HISTORIC AND DESIGN REVIEW COMMISSION

October 01, 2014
Agenda Item No: 14

HDRC CASE NO: 2014-289
ADDRESS: 840 E Mulberry, 731 E Huisache, 743 E Huisache
LEGAL DESCRIPTION: NCB 2806 BLK LOT 56 BELK SUBD
NCB 6077 BLK 1 LOT 8-10
NCB 6077 BLK 1 LOT 11
ZONING: MF50-DN RIO-1
CITY COUNCIL DIST.: 1
DISTRICT: RIO-1
APPLICANT: Tom Guggolz
OWNER: Brackenridge Gardens Ltd
TYPE OF WORK: New construction of multifamily apartments and townhomes
REQUEST:

Construct a 4-story apartment building on the vacant lot at 840 E Mulberry and 2-story townhome units along E Mulberry. Proposed materials for the requested new construction consist of corrugated metal, metal panels, perforated metal, wire mesh and stucco. Surface parking for the units will be located internally within the site.

C1 | SOUTH ELEVATION
SCALE: 1/8" = 1'-0"

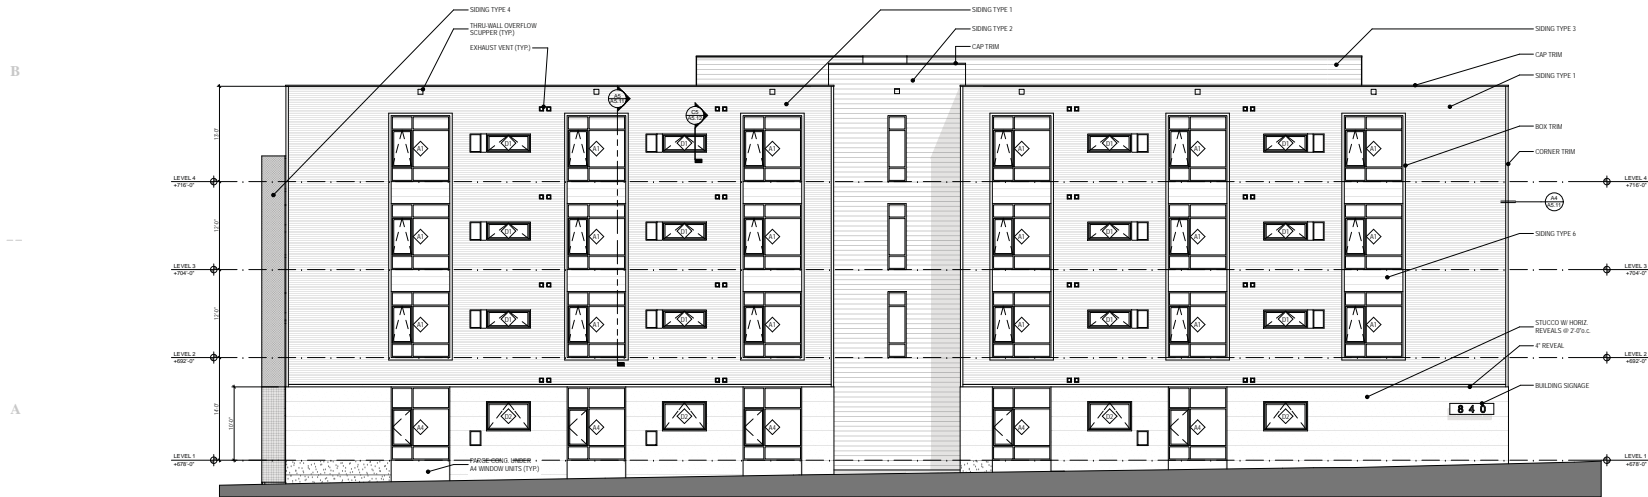
- b. This request was reviewed by the Design Review Committee again on September 9, 2014, to assess the proposed materials for the project. The applicant presented other examples located within the RIO which incorporate similar materials. The committee members present agreed that there was precedent and that the selected materials would provide sufficient shadow lines consistent with the intent of UDC Section 672(d). There was concern expressed over the length of unbroken facade, particularly along Mulberry.

- f. UDC Section 35-672(d) requires that at least 75% of building surfaces implement exterior materials that are either traditional or convey a human scale. Brick, or other masonry units, are strongly encouraged. It is unclear whether the

proposed metal siding types meet this requirement. The use of traditional masonry units would be more consistent with the UDC.

- g. UDC Section 35-672(e) provides guidance for the façade composition of new buildings in the RIO. New buildings should have an articulated base, middle and cap. The base (ground floor) of the proposed new construction is clearly distinguished by a change in materials. However, staff finds that the proposed new construction lacks a traditional “cap”. While a modern design is not expressly discouraged in the UDC, staff finds that the applicant should explore ways to incorporate this required cap element into the design.

- 1) That a detailed landscape plan be submitted for HDRC review based on finding c.
- 2) That more traditional building materials, such brick or other masonry units, be incorporated into the façade based on finding f..
- 3) That an archaeological investigation occurs prior to any construction activity and that results are submitted to OHP staff for concurrence based on finding i.
